Project Proposal

Property Address 814 W. Laramie Lane

Attention:
Village of Bayside, WI
Architecture Review Committee

<p>PROJECT/SITE OWNER: Property Owners 814 W Laramie Lane</p> <p>PROJECT ADDRESS: 814 W Laramie Lane</p>	<p>PROJECT SUMMARY: New shed in rear yard with new driveway. Shed finish materials will match existing house style.</p>
--	--

PROPOSED NEW CONSTRUCTION LOCATION

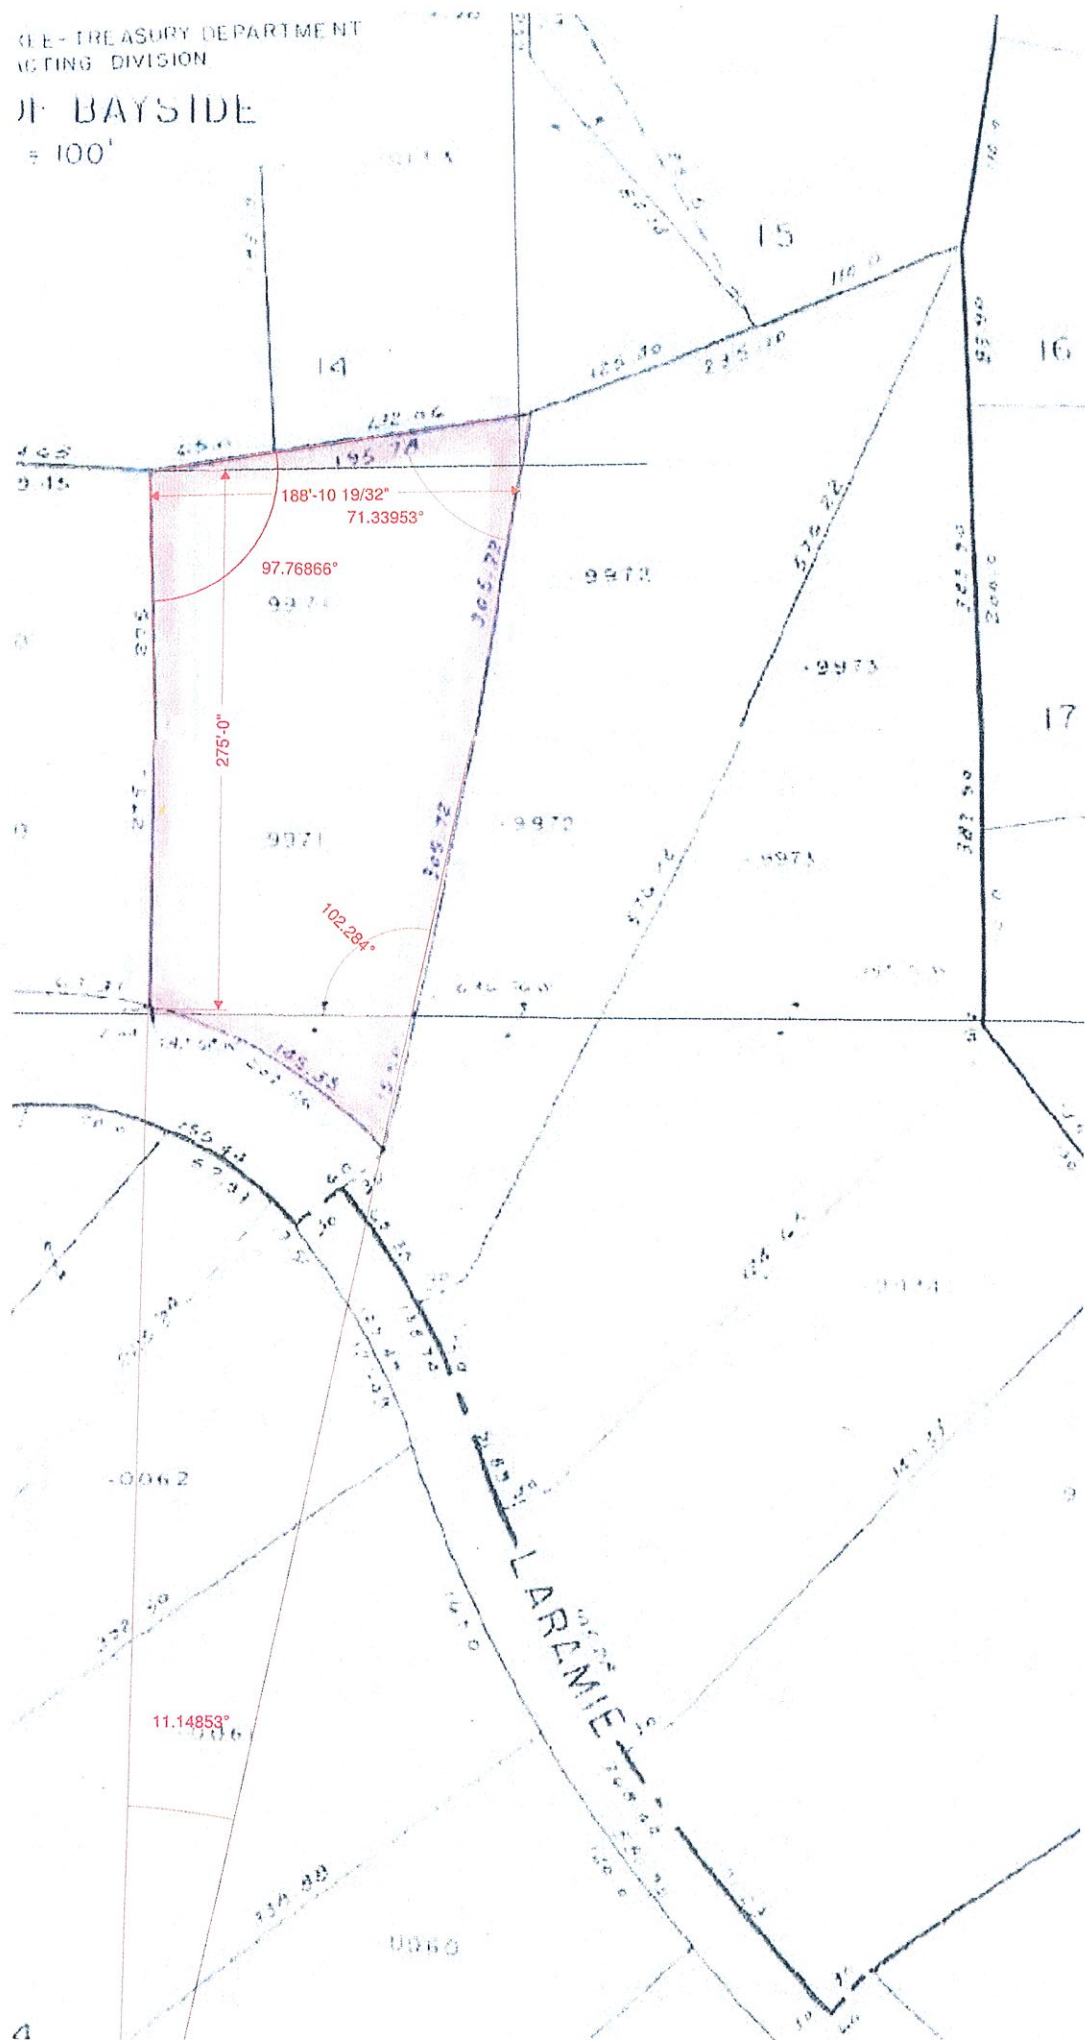
Per Village code section 104-4 (f), copied below, all accessory structures shall be located behind the rear of the extended rear line of the residence located upon the lot. Shed shall be relocated behind the extended rear line of the existing house.

(f) Except as provided herein, the construction or placement of all accessory structures must comply with the rear and side yard setbacks provided by the zoning ordinances as applicable to structures. All accessory structures shall be located to the rear of the extended rear line of the residence located upon the lot, and with respect to corner residences, shall be located behind the extended rear line and the extended side line adjacent to the street of the residence located on the lot.

Proposed shed location was revised and now complies with Village Code. SAFEbuilt recommends approval.
